Cumberland County Subdivision and Land Development Review Report

Municipality:	South Middleton	Surveyor/ Engineer:	Diffenbaugh Wadel	Owner/ Developer:	Carlisle Reformed Presbyterian Church		
Plat Title:	Carlisle Reformed Presbyterian Church						
Plat Status:	Preliminary/Final	Plat Type:	Land Development				
# of New Lots:	0	# of New Dwelling Units:	0	New Acreage Subdivided/Developed:	0	Total Tract Acreage:	6.16
Zoning District:	C-2	Proposed Land Use:	Same as existing				
Date Received:	3/27/2020	County Review:	4/4/2020	Reviewed by:	SH	Checked by:

FINAL LAND DEVELOPMENT PLAN FOR
CARLISLE REFORMED
PRESBYTERIAN CHURCH
SOUTH MIDDLETON TOWNSHIP · CUMBERLAND COUNTY · COMMONWEALTH OF PENNSYLVANIA

Date	MARCH 25, 2020
Scale	1" = 20'
File No.	20012
Drawing Name	20012-LD2
Drawn By	J.B.M.
Project Manager	Michael L. Wadel
Sheet No.	LD2

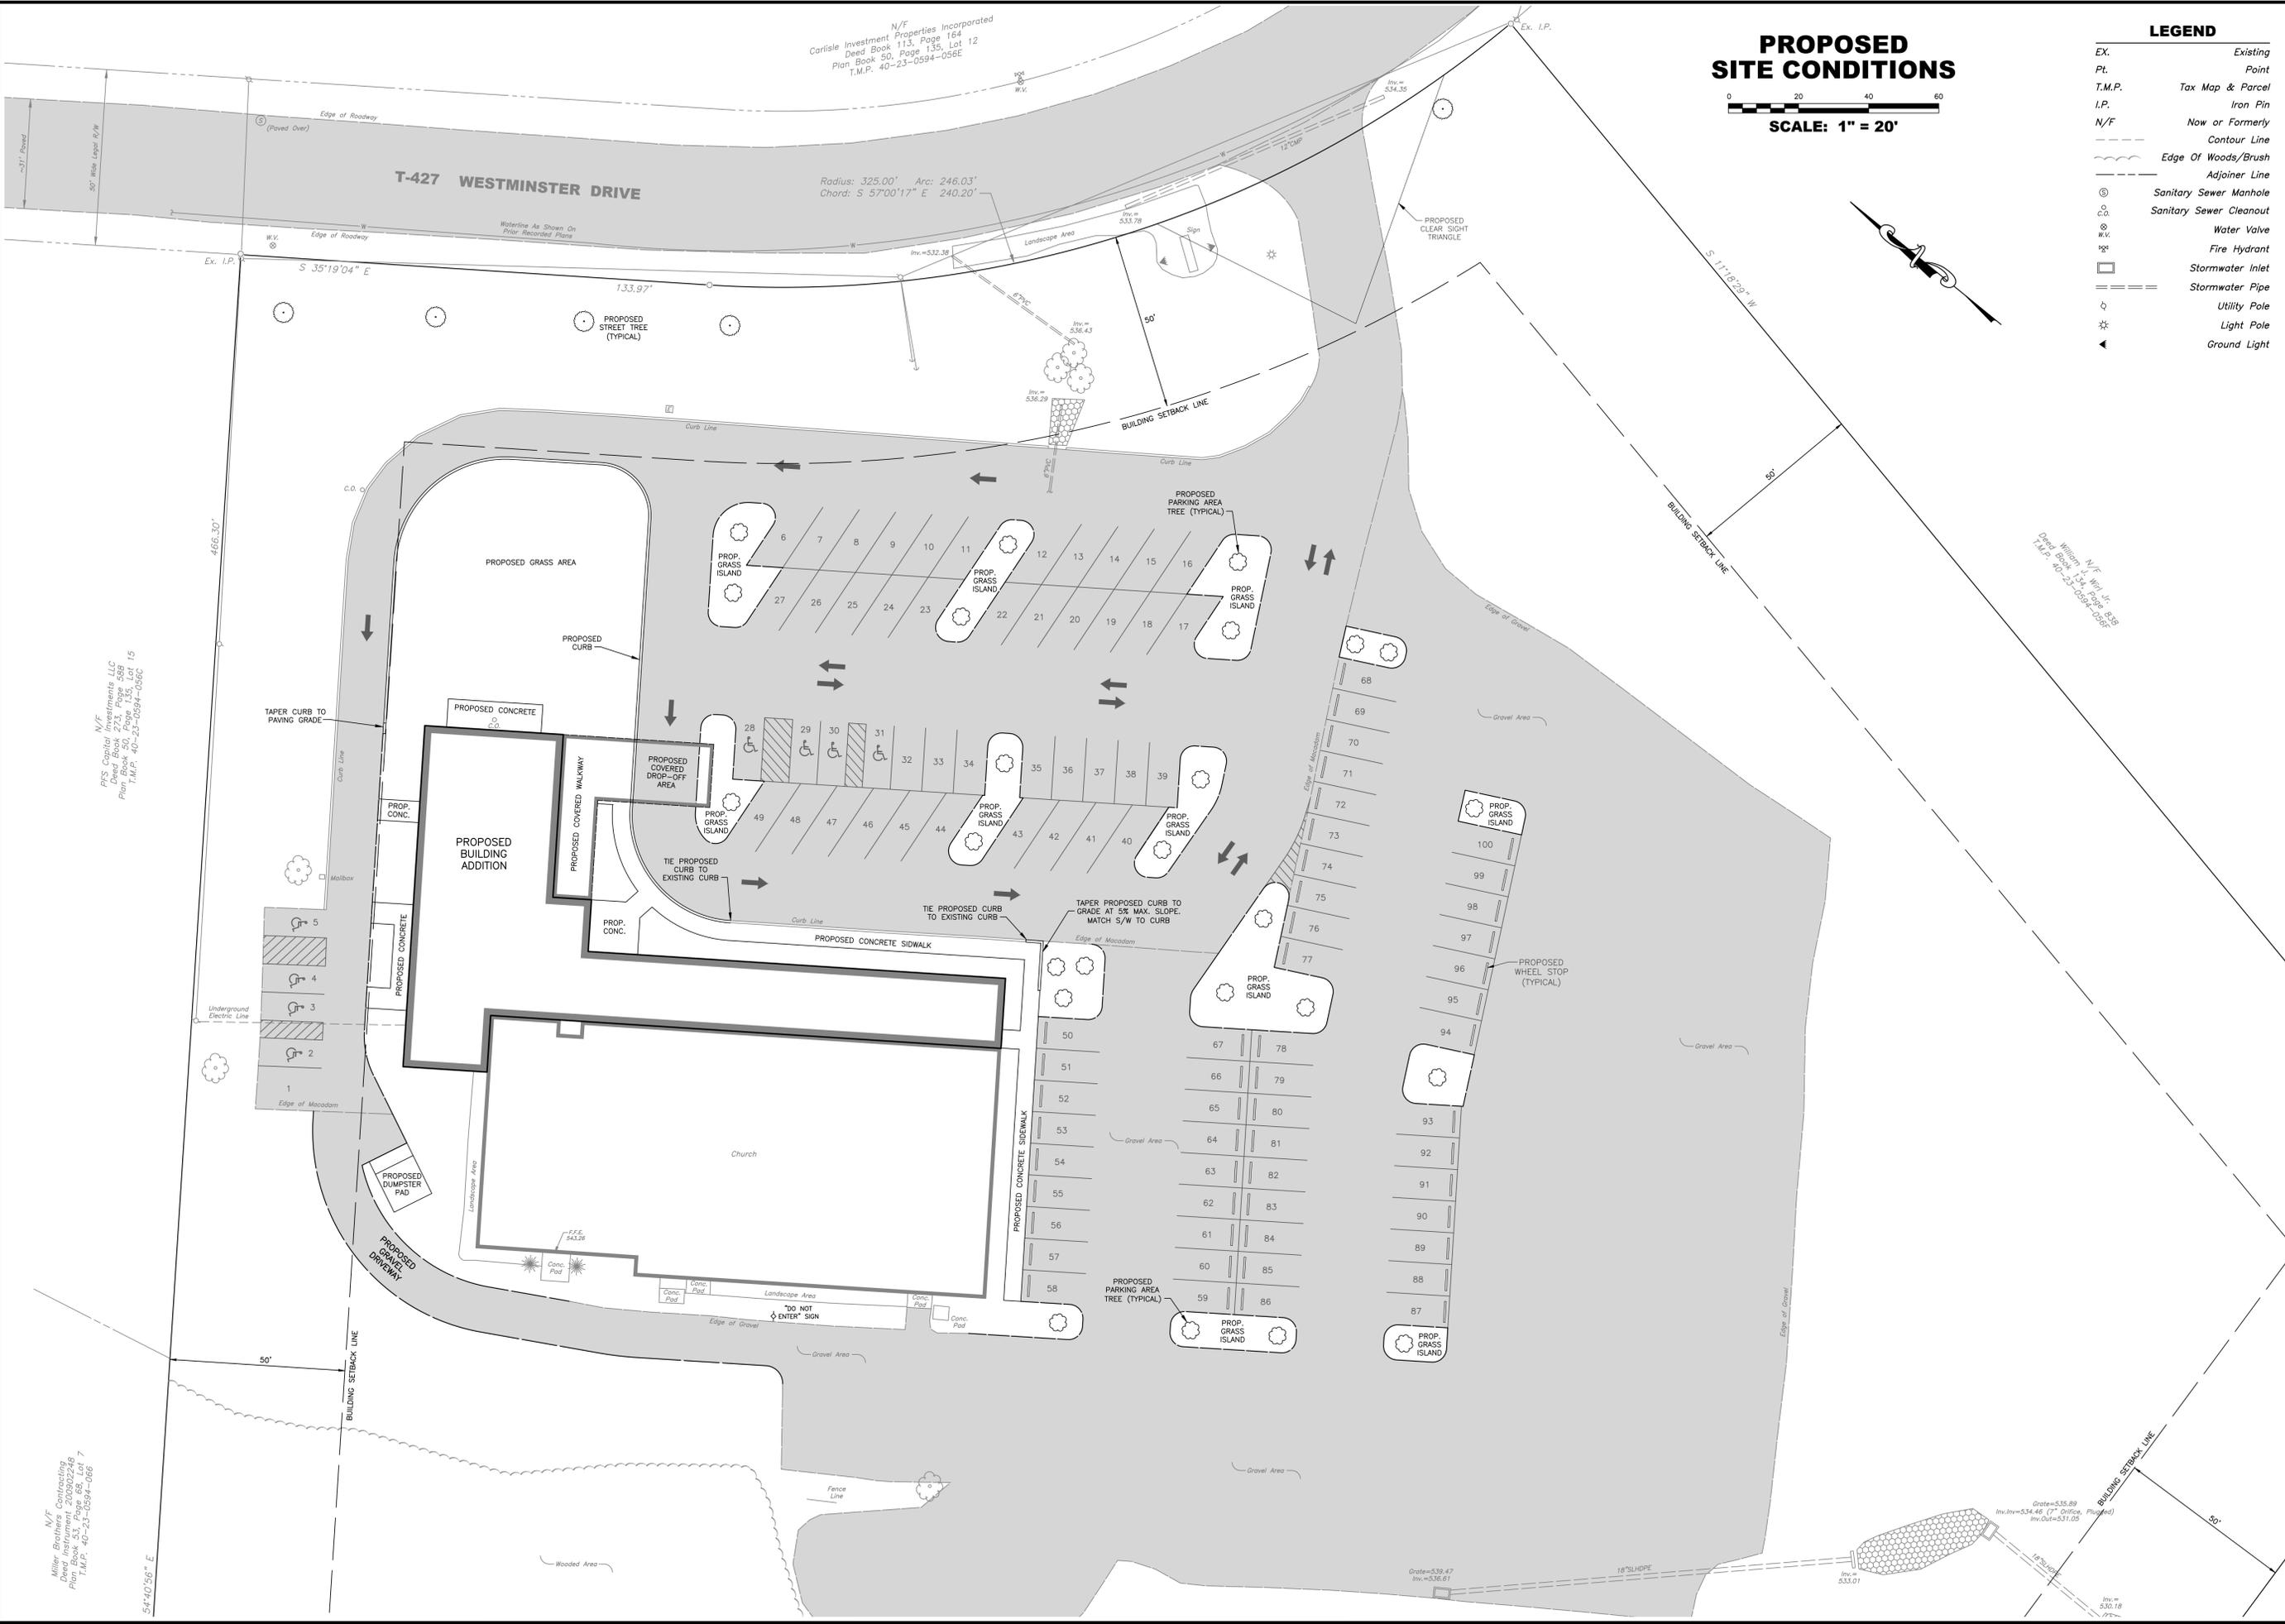
2. The plan should include required and proposed building coverage figures (Zoning 1202.4.A).
3. The width of interior drives between parking spaces should be indicated on the plan (Zoning 1802.1)

4. The required and provided sight distance should be shown on the plan (Zoning 1807.5).
5. The plan should reference the date of the Conditional Use Hearing and any additional requirements as a result of the Hearing (Zoning Article XX).

9. The plan should indicate a dedication of recreation land or a fee in lieu of dedication (SLDO 606).
10. The plan should include curbing or some other method to protect the proposed grass islands (SLDO 711.B.2.J.iii.2).
